Schuman-Livengood intersection channel does not exist

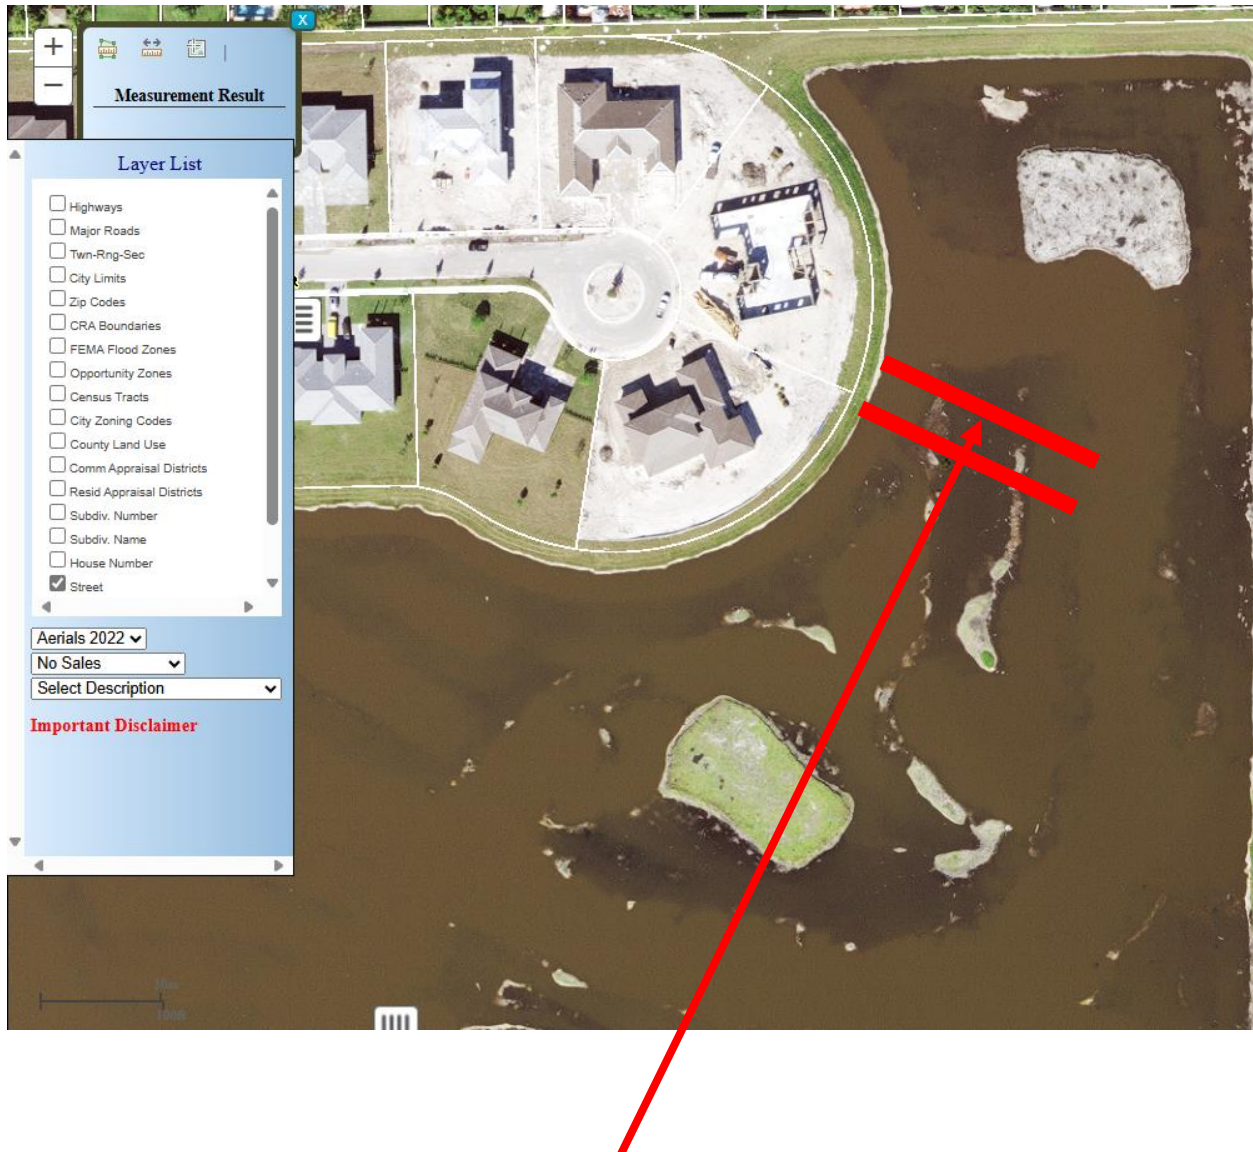
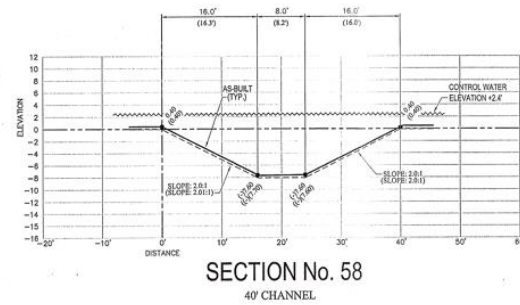
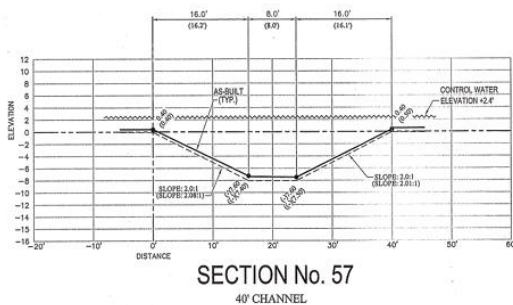
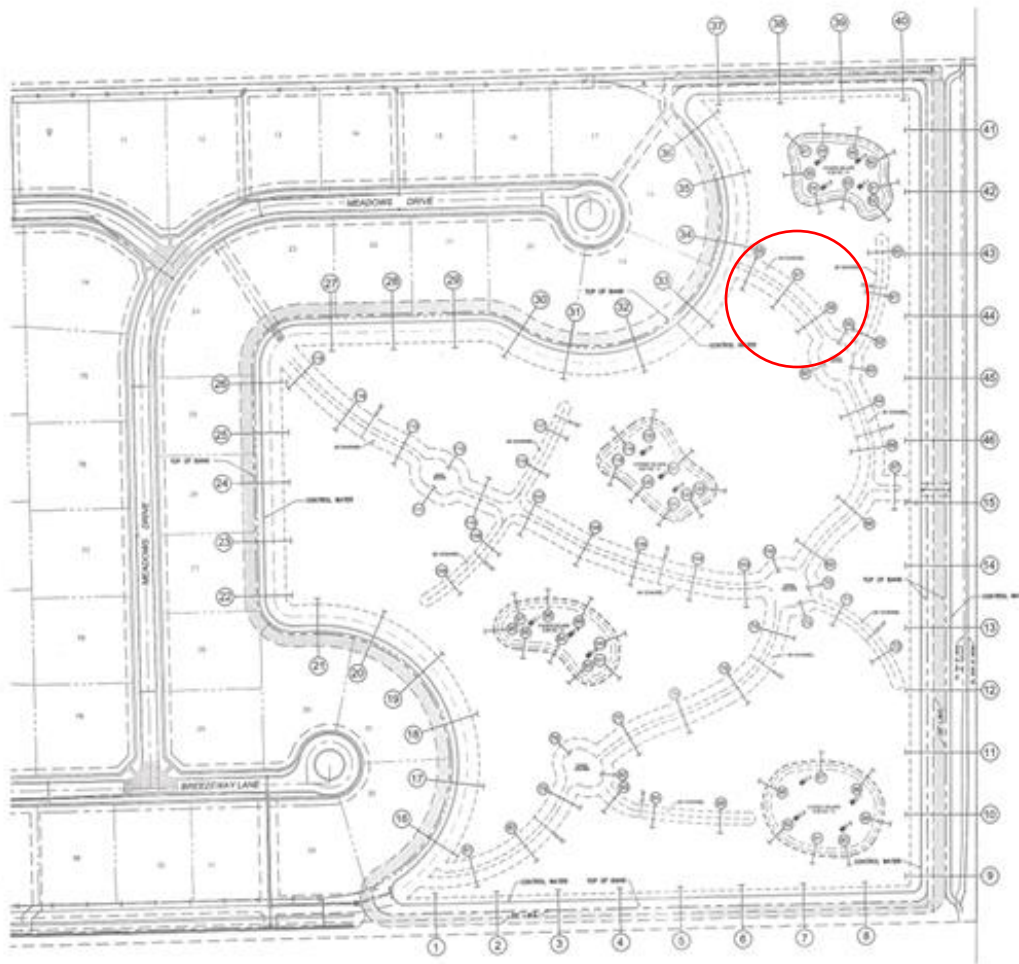
Impossible to have a 10-foot deep channel here. Is the as-built provided by developer not then completely fraudulent showing something that does not even exist?

Vimeo Link showing that this 10 foot deep flow channel is entirely covered with nuisance species that is not in the plan:
